Admin. approval of minor changes made to the EPC approved Site Plan to avoid existing utility lines that were not located correctly on the site survey (relocating dumpster enclosure); and to address constructability and durability concerns (minor adjustments to ext. facades).

EPC #20018-001760 / SI-2018-00223; City Council Hearing File # AC-19-2; SI-2019-00308

The purpose of this letter is to provide justification for the minor changes that have been made to the Environmental Planning Commission (EPC) approved Site Plan for the Singing Arrow Community Center located at 13200 Wenonah Avenue SE, in the Canada Village – Second Unit Subdivision in response to issues that have arisen during the construction of the project. The relevant project numbers for this project are: EPC Project #20018-001760/SI-2018-00223, City Council Public Hearing File #AC-19-2; and SI-2019-00308.

## SINGING ARROW COMMUNITY CENTER ENLARGED SITE PLAN

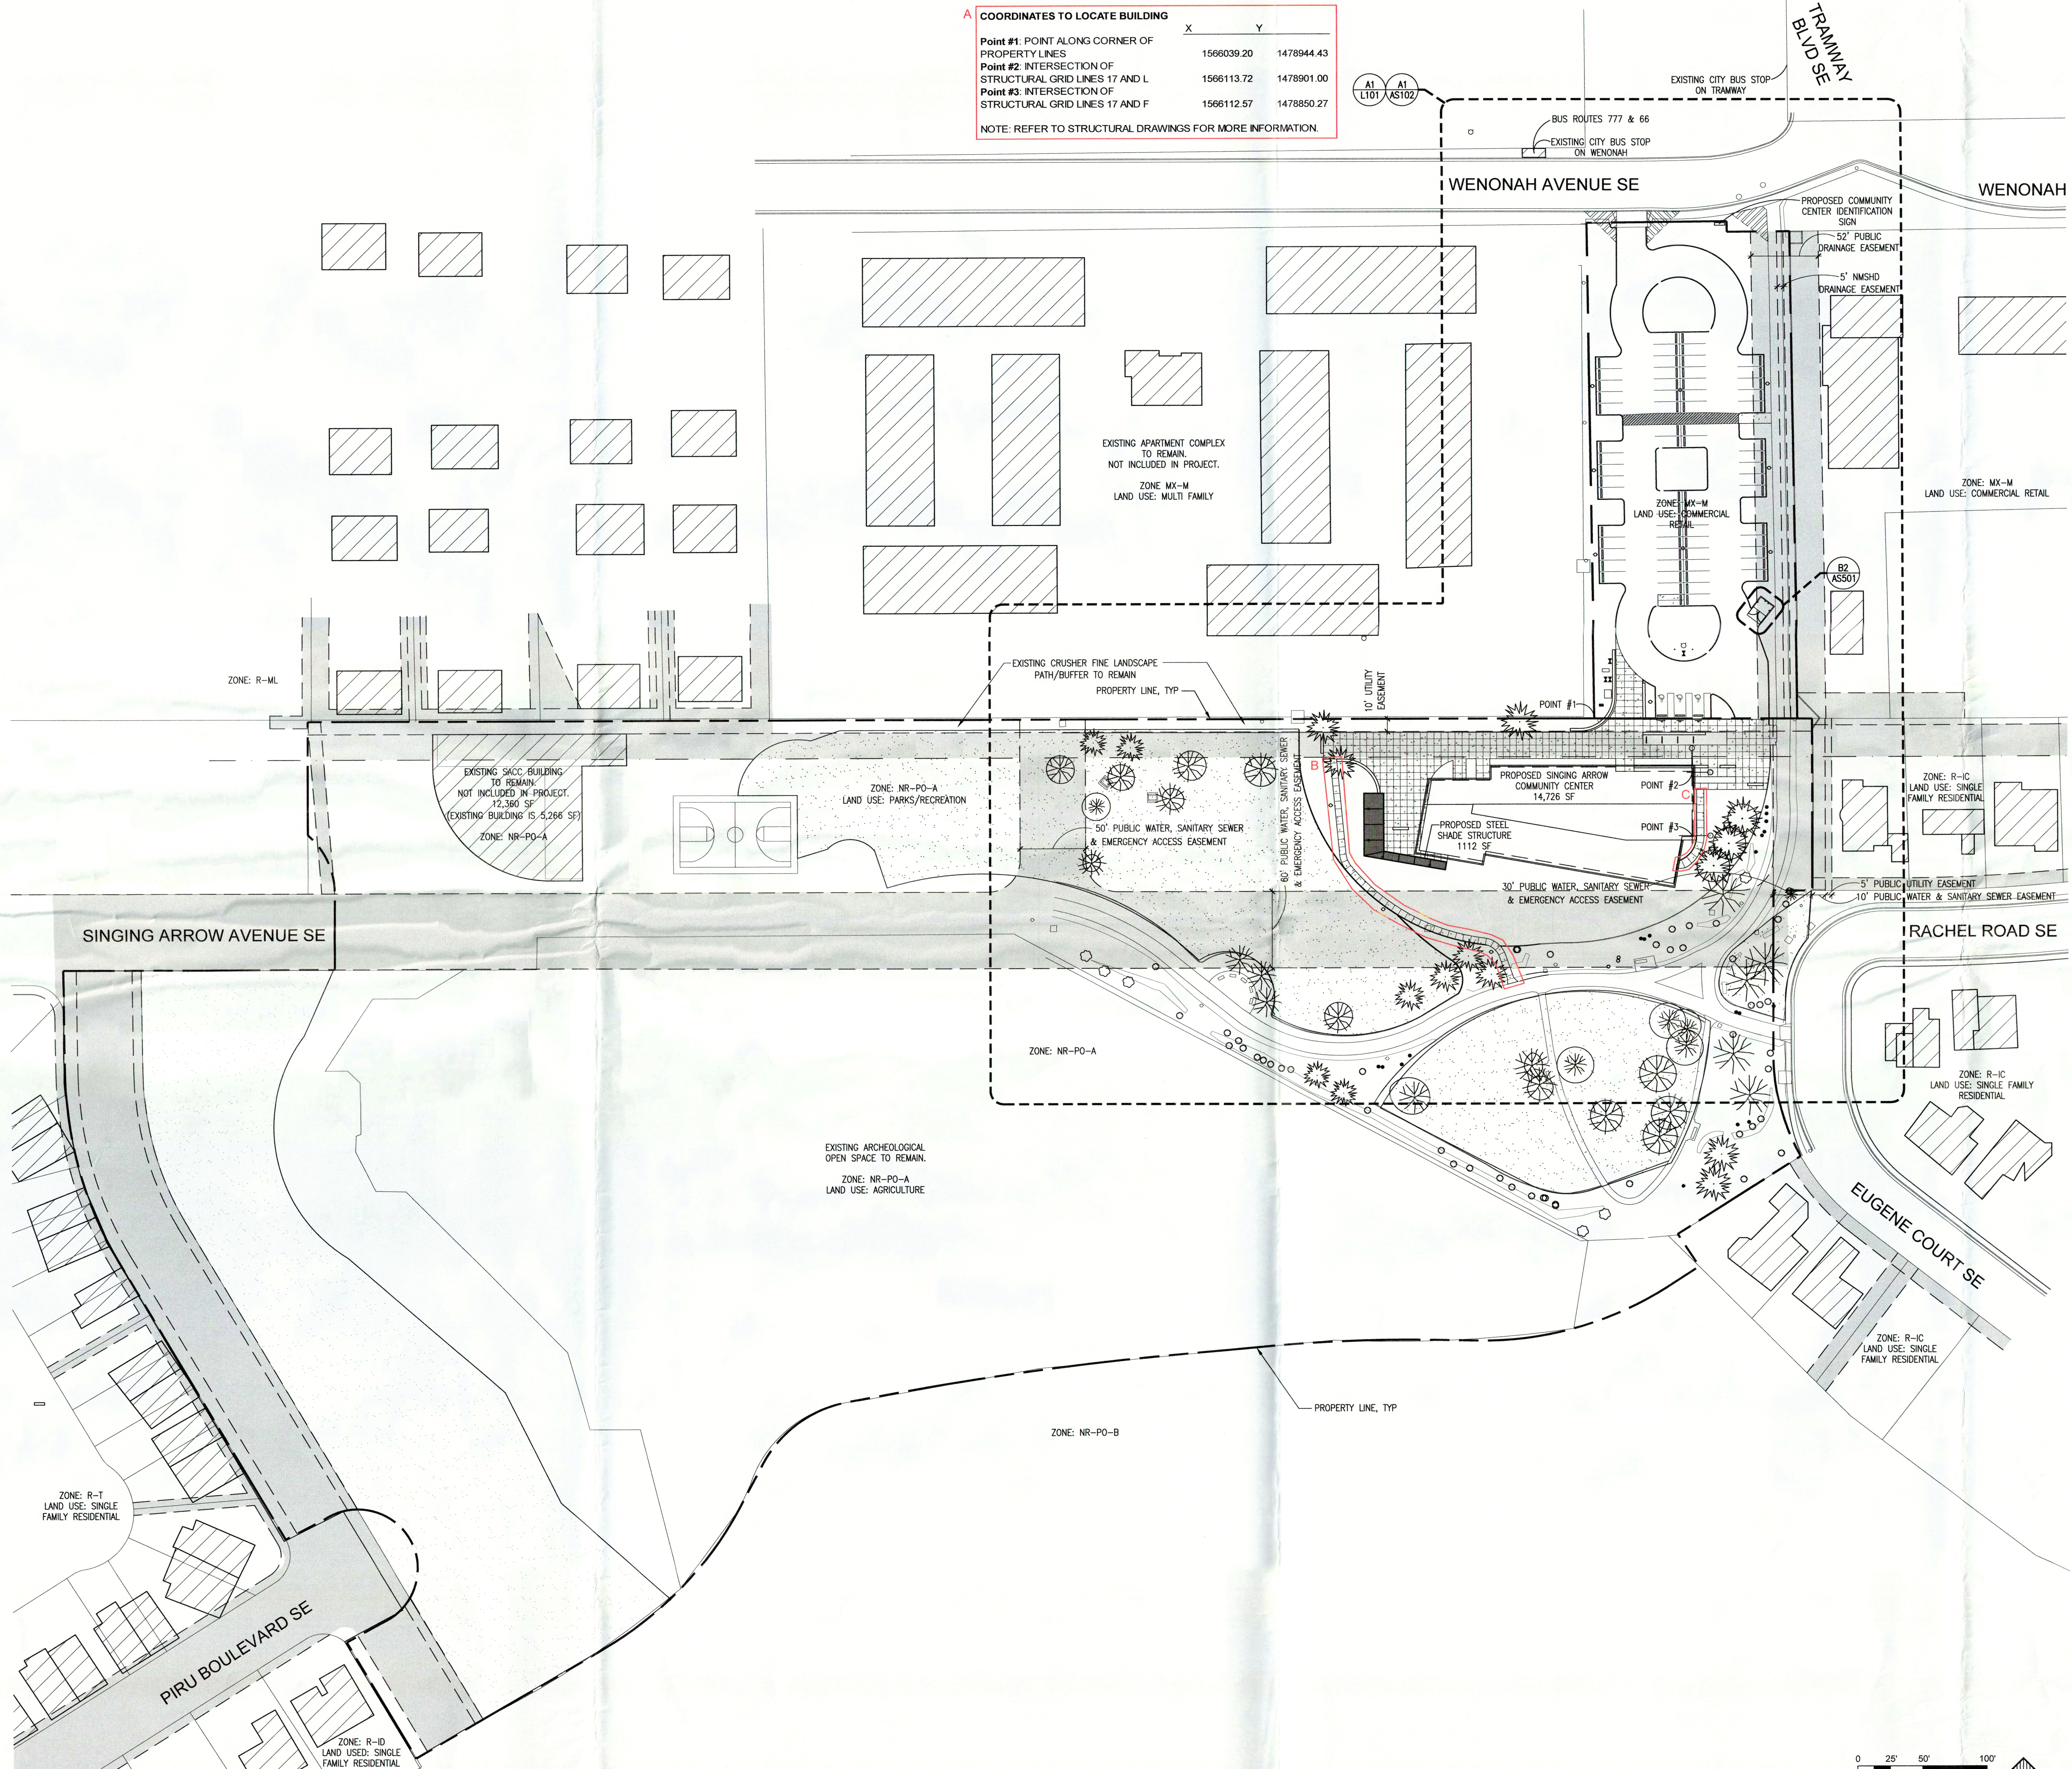
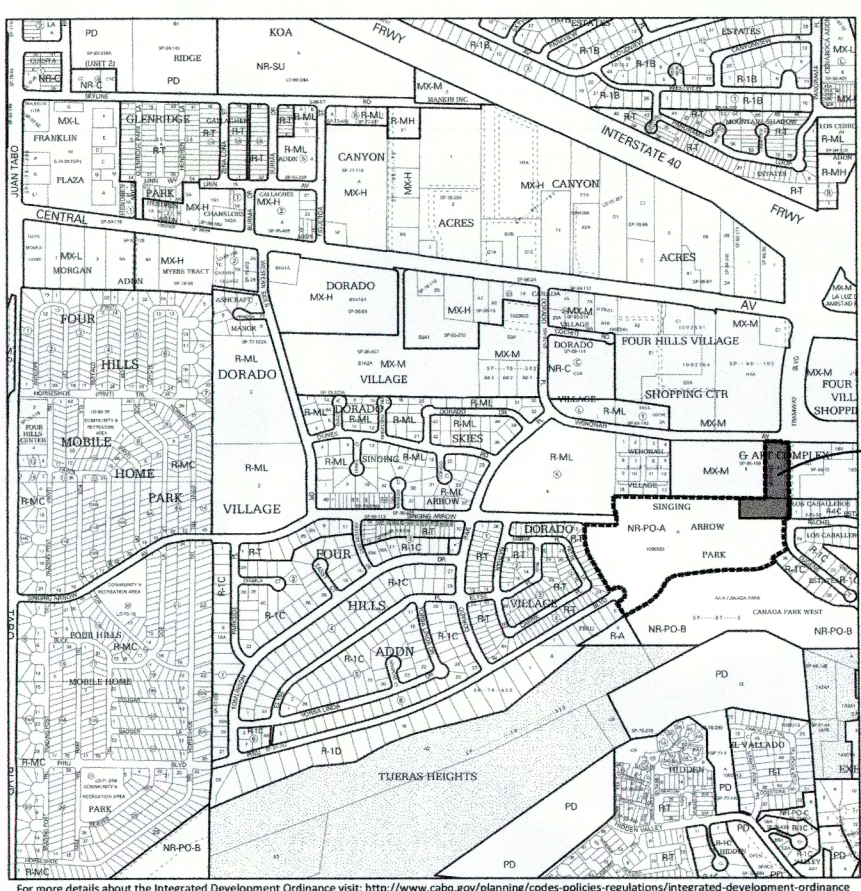
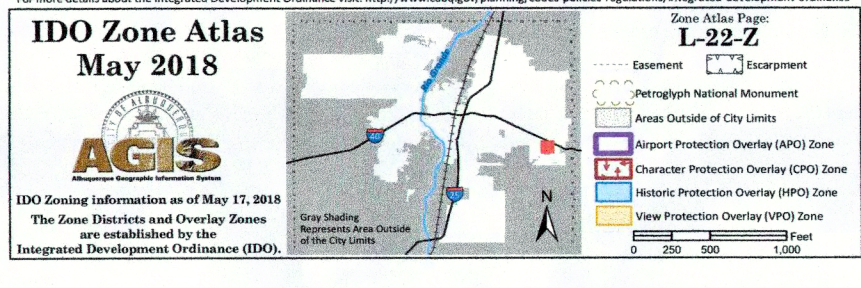
- F. Six bollards were added at the transformer pad to meet PNM requirements. (MCR #010).
- G. The dumpster enclosure was moved from the east edge of the parking lot to the west edge of the parking lot to avoid existing utility lines uncovered at the east edge of the site. An existing water line was shown on the survey approximately 15'-0" away from its actual location in the field. (MCR #020)

- a. Modify curbs, planting areas, and parking spaces to provide proper clearances and access.
  - b. Shift 3 parking spaces north, and shift adjacent graded retention planting area south to provide all required access to the dumpster enclosure. Area of graded retention planter to be the same or equal as that approved in the Site Development Plan.

- d. At east side of parking lot, modify curb and planter area to smooth out curbs at the old location for the dumpster enclosure.
- H. Update Parking Calculations per changes listed in G.c. above.

- I. Remove two trees that were identified to be retained on the Site Plan to provide required access for all grading equipment to maneuver the site, and clear (ASI #04). Provide two new deodar cedar trees to replace the two removed trees (ASI #09). Total number of trees included on the approved Site Plan will be the same.

- J. At west end of the building and at the north fire lane, modify the curb details and gabion bench locations. Remove small portion (approximately 115 sf) of concrete at southwest end of building. (ASI #08).

- a. Relocate gabion benches on west side of site to be located under shade structure, and to provide improved edge condition at concrete drive pad. Total quantity of gabions provided is unchanged.

- K. Make minor modification to layout of concrete walkway outside of door 121B on east side of building to meet all ADA accessibility requirements (ASI #29). Total amount of concrete is approximately 10 sf more than what is included on the approved Site Plan.

REMOVE GABION BENCHES FROM INDICATED AREAS (50 LF OF GABION BENCHES REMOVED). RELOCATE GABION BENCHES AT SOUTH AND WEST SIDES OF CONCRETE (50 LF OF GABION BENCHES RELOCATED)

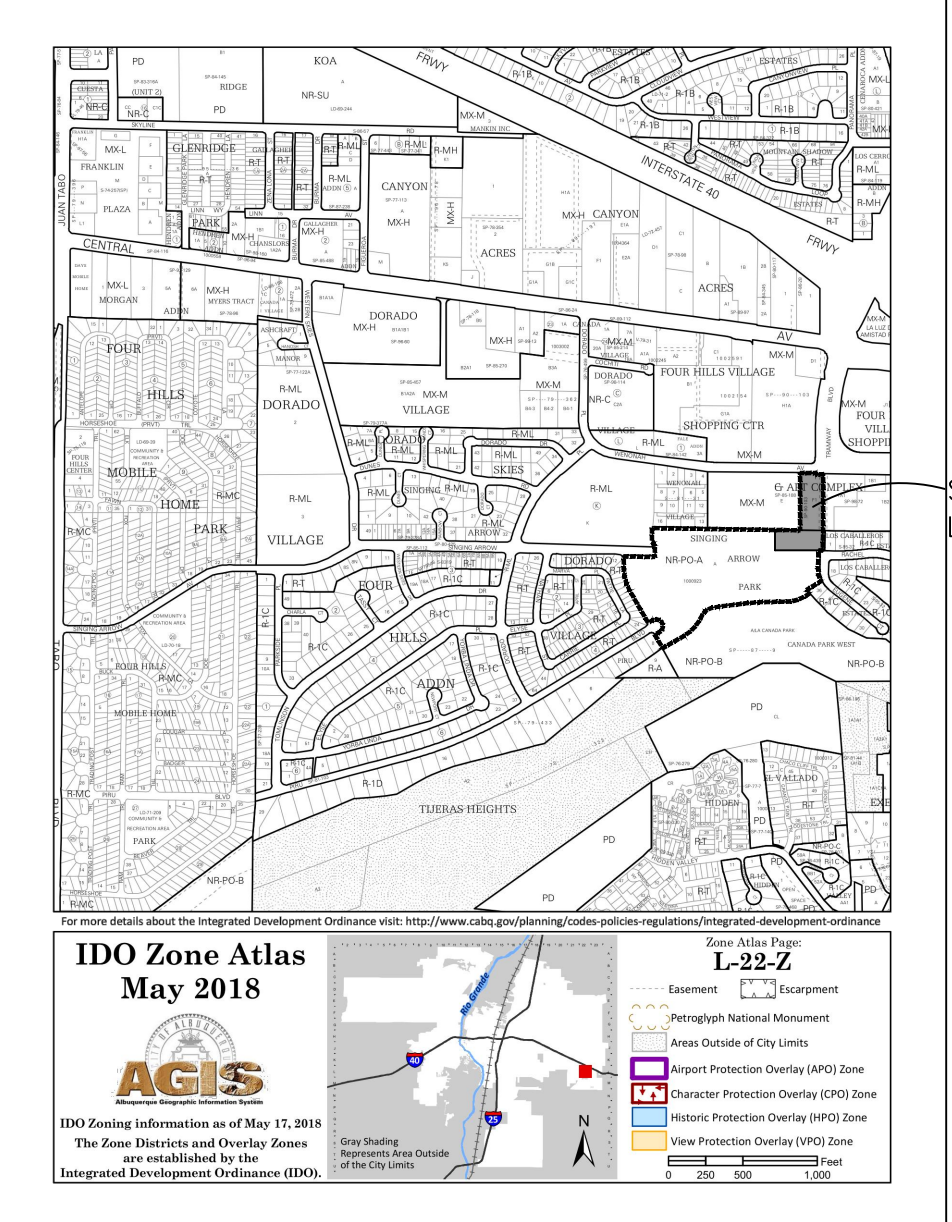
- C. We added a “Shade Structure Horizontal Control Points” chart to AS101 to provide additional information to the contractor, so they can accurately lay out the columns and footings for the shade structure. This does not change any information previously approved by the EPC and City Council, rather it draws out the information in a different format. Refer to Overall Site Plan drawing for notations of Points 4 through 7 as related to the property line and building.
- D. A 20’-0” public waterline easement was added per requirements from the ABCWUA.

FAÇADE CALCULATIONS					
FAÇADE	TOTAL OPAQUE SF	FRAME SF	TILE SF	DIMENSIONAL SIGNAGE SF	STUCCO ACCENT SF
NORTH	3,866.0	116.0	111	60	0
EAST	1,740.1	36.0	492	0	9.0
SOUTH	4,125.9	97.7	513	0	0
WEST	1,281.4	53.0	44	0	5.4
TOTALS	11,013.4	281.7	1,160.0	60.0	14.4

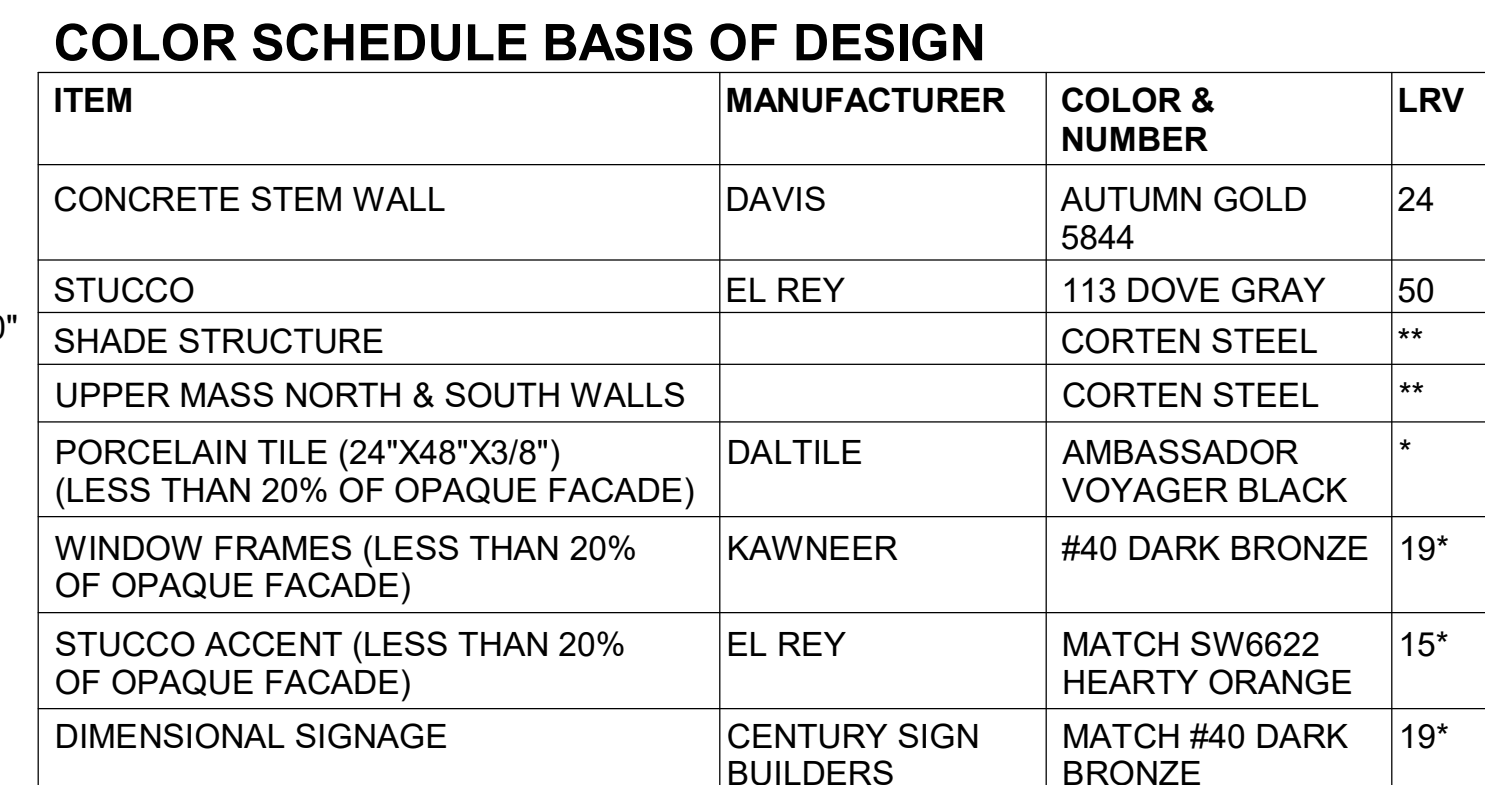
- Q. At the north and south facades of the building, the size and shape of the stucco portions of the wall were modified slightly to provide for cleaner details at the base and overhangs of the wall, and to ensure improved durability at the areas under the windows. In response, the areas that are finished in exterior tile expanded slightly. (MCR #011).

- a. The total opaque square footage remains unchanged. See façade calculations chart on A-201 for updated calculations.
  - b. The total square footage of exterior tile changed from 1,098 sf to 1,160 sf (a 5% change).

- c. The total square footage of stucco changed from 9,559.3 sf to 9,157 sf (a 4% change).
- R. Corten steel cover plates were added at all exterior roof drain/overflow roof drain penetrations to provide improved durability and weather tightness in those areas (MCR #011). An additional set of roof drain/overflow roof drain penetrations was added on the north side of the building to allow for improved sloping of the roof drain piping inside the building (ASI #15).
